Overview of 650MHz Test Stand and Results of PDR

650 CTL FDR

September 24, 2020

- The PIP2IT 650 MHz Test Stand Intermediate Cryo Transfer Line Final Design Review (650 CTL FDR) is an independent evaluation of the final design of the new intermediate cryogenic transfer line that is needed to tie the existing PIP2IT cryo transfer line (CTL) to the 650 MHz cryomodules that will be tested in the PIP2IT cave. The review committee is requested to assess/answer the following questions:

Conceptual model of 650 Test Stand showing intermediate CTL (orange)

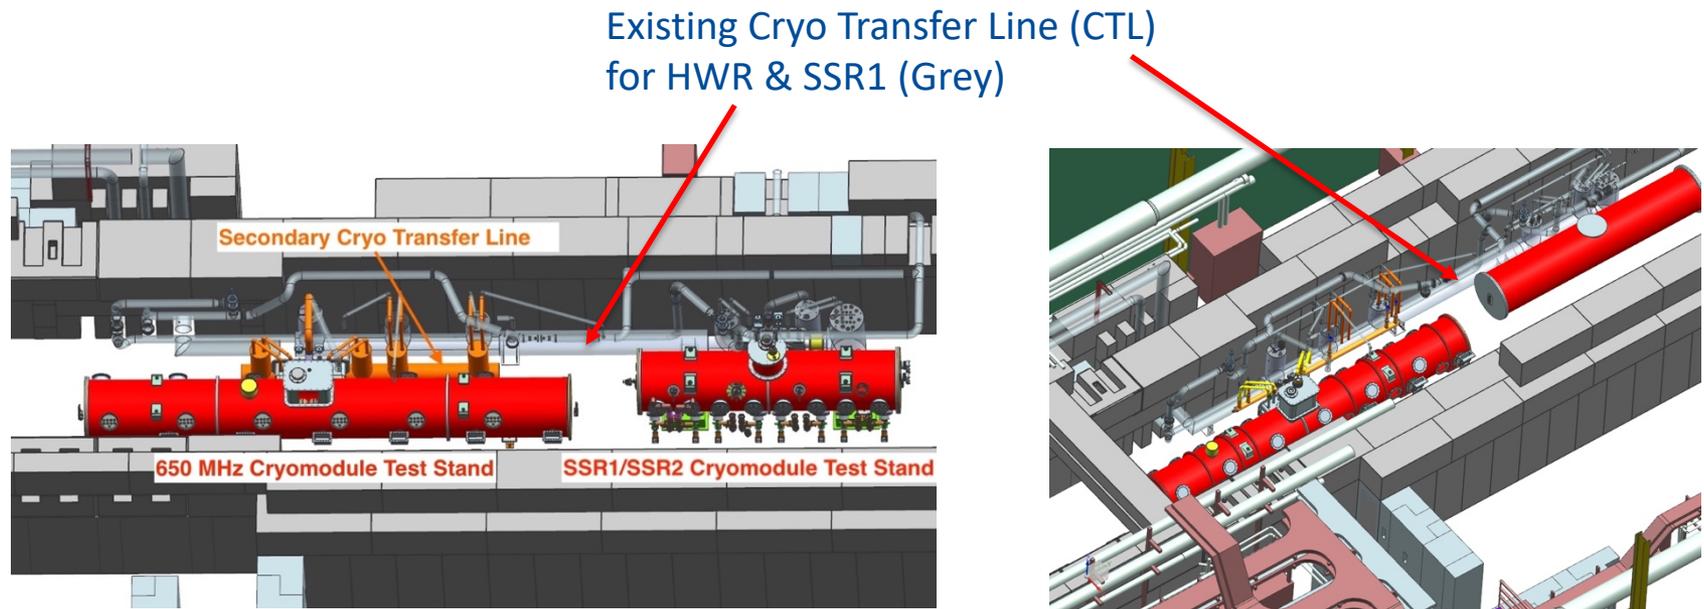
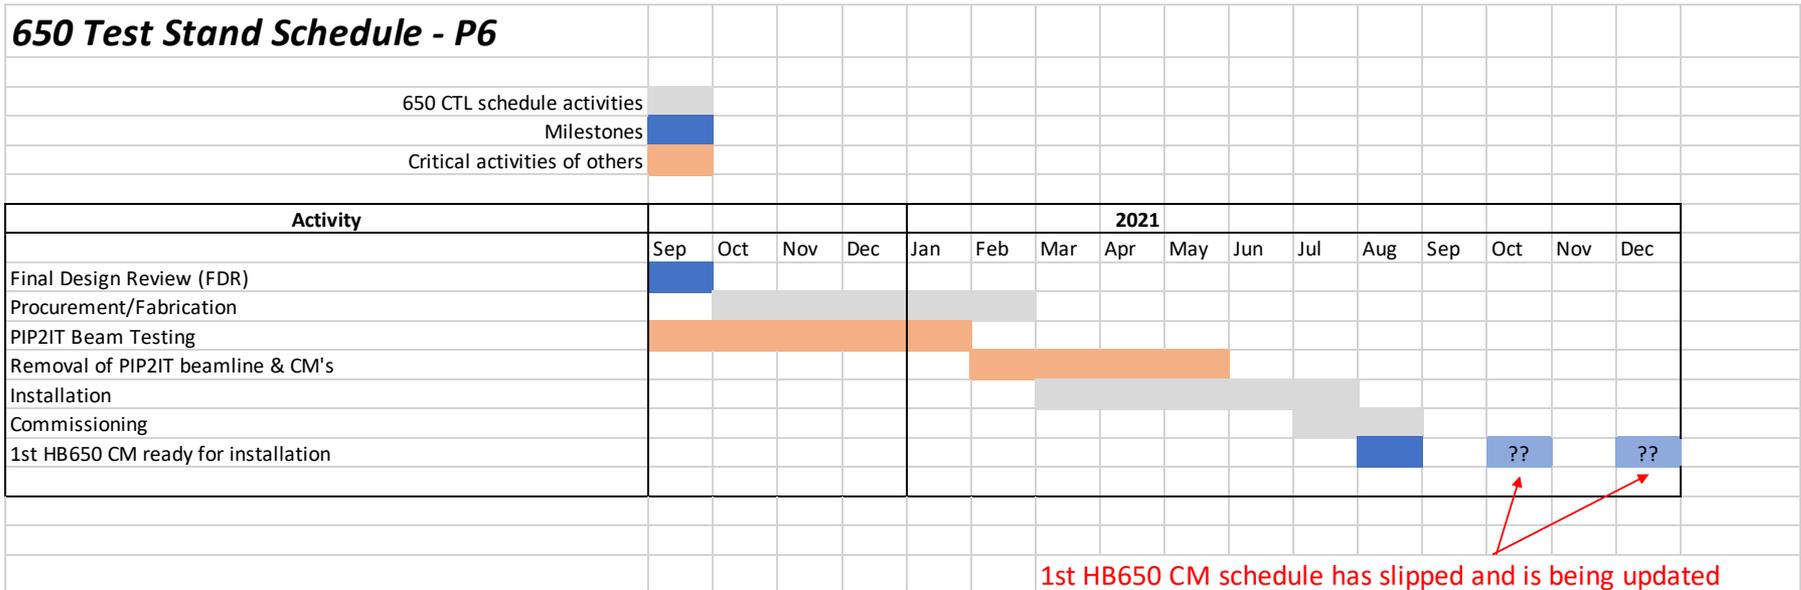
- Held on April 22nd
- Same Review Committee
- 7 Recommendations - detailed in the [Review Response form \(SDP doc#10\)](#)

- 1 - Add vacuum parallel plate by the FDR. Make sure location good for u-tube pulls. Make sure stands and platform do not interfere.
 - Included in Joe's presentation and (drawings/3D models)
- 2 - Finish preliminary helium relief requirements by the FDR. Apply this to size the relieve valves.
 - Included in Joe's presentation and (SDP doc#14)
- 3 - Develop preliminary design for CTL supports and platforms necessary for U-tube installation/ removal by the FDR.
 - Included in Joe's presentation and (drawings/3D models)

- 4 - Develop preliminary procedure for isolation, depressurization, and U-tube installation/removal by the FDR. Verify that technicians have sufficient access to perform all steps in the procedure.
 - Included in Joe's presentation and (SDP doc#19 & 3D models)
- 5 - Check tolerance specifications and investigate U-tube design to ensure that a common U-tube set can be used for all cryomodules by the FDR.
 - Discussed in Joe's presentation

- 6 - Consider a means to ensure that a flex hose is not overstressed should a spider hang up by the FDR.
 - Included in Joe's presentation and (SDP doc#15)
- 7 - Consider lowering the elevation of the horizontal section of the CTL toward the floor to help simplify the CTL stand and to allow a platform over it to make U-tube access easier by the FDR.
 - Included in Joe's presentation and (drawings/3D models)

- The existing CTL was designed for the HWR cryomodule and does not mate up directly with the 650MHz cryomodules
- A secondary or “intermediate” CTL was designed to tie the existing CTL to the 650 cryomodule – *Joe’s talk*
